SUBJECT: SEABROOK STATION, UNIT NO. 1 – ISSUANCE OF AMENDMENT NO. 168  
RE: CHANGING TIME DELAY SETPOINTS FOR DEGRADED VOLTAGE  
RELAYS (EPID L-2020-LLA-0012)

The amendment revised the trip setpoint and allowable value for the degraded voltage time delay relays for Functional Unit 9.b, “4.16 kV [kiloVolt] Bus E5 and E6 Degraded Voltage.”

SAFETY EVALUATION BY THE OFFICE OF NUCLEAR REACTOR REGULATION

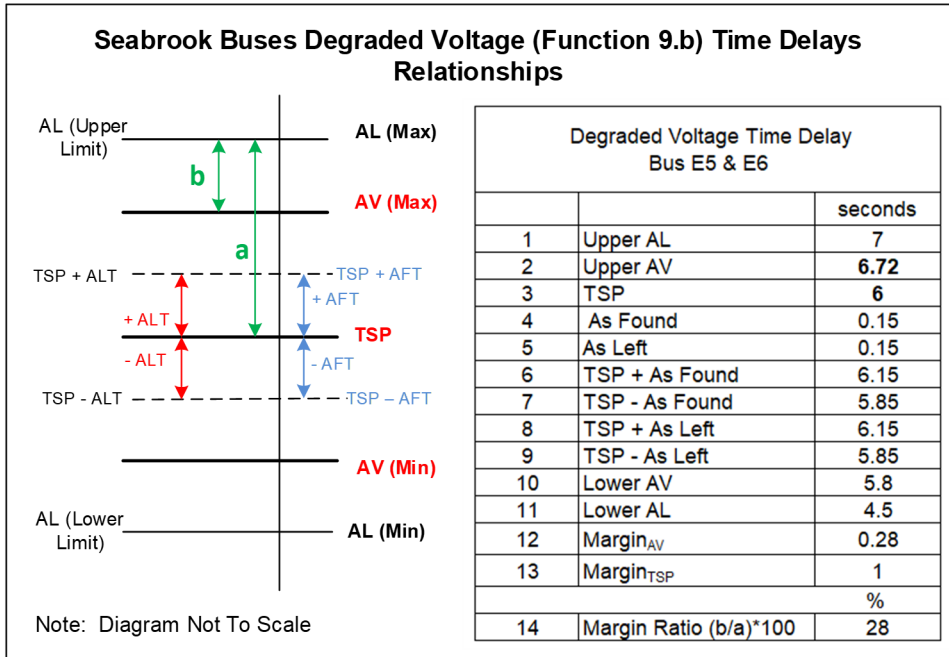
The NRC staff performed an independent confirmation evaluation of the following margins to determine whether there is a positive margin: between the AL and the TSP ( $\text{Margin}_{\text{TSP}}$ ), and between the AL and the AV ( $\text{Margin}_{\text{AV}}$ ).

$$\begin{aligned}\text{Margin}_{\text{AV}} (b) &= \text{AL} - \text{AV} \\ \text{Margin}_{\text{TSP}} (a) &= \text{AL} - \text{TSP}\end{aligned}$$

$$\text{Margin Ratio percent} = (b/a) \times 100 \text{ percent}$$

The NRC staff performed a confirmation evaluation of the  $\text{Margin}_{\text{TSP}}$  and  $\text{Margin}_{\text{AV}}$  of the Upper Level time delay only because the proposed maximum degraded voltage time delay relays that detect the degradation of the 4.16 kV buses E5 and E6 should be limited to protect the Class 1E loads from damaged or unavailability.

The NRC staff's evaluation is summarized in the figure below.

The NRC staff determined that:

- The TSP inclusive of its As-Found Tolerances, is less than the maximum AV and greater than the minimum AV to ensure that the trip signals will be initiated before TSP reach the AV values.
- The margin ratio percentages between the TSP and AV margins are greater than 28 percent and are adequate. These margins ensure that the trip setpoints have been chosen to ensure that a trip or safety actuation will occur significantly before the measured process reaches the Upper Analytical Limits. The proposed AV setting is an automatic protective action that will correct the abnormal situation before a safety limit is exceeded.
- The proposed maximum/minimum AV is in the time delay setting range of 1.5 to 15 seconds of the Agastat 7012 PC timing relays to maintain these variables and systems within prescribed operating ranges.

Based on the above discussion, the NRC staff finds that the proposed AV of the degraded voltage time delay settings (TSP and AV for the Functional Unit 9.b in TS Table 3.3-4) is consistent with RG 1.105 and satisfies the requirements of 10 CFR 50.36(c)(1)(ii)(A) and GDC 13. Therefore, the proposed TSP ( $\leq 6$  seconds) and AV ( $\leq 6.72$  seconds) of time delay relay settings are acceptable.
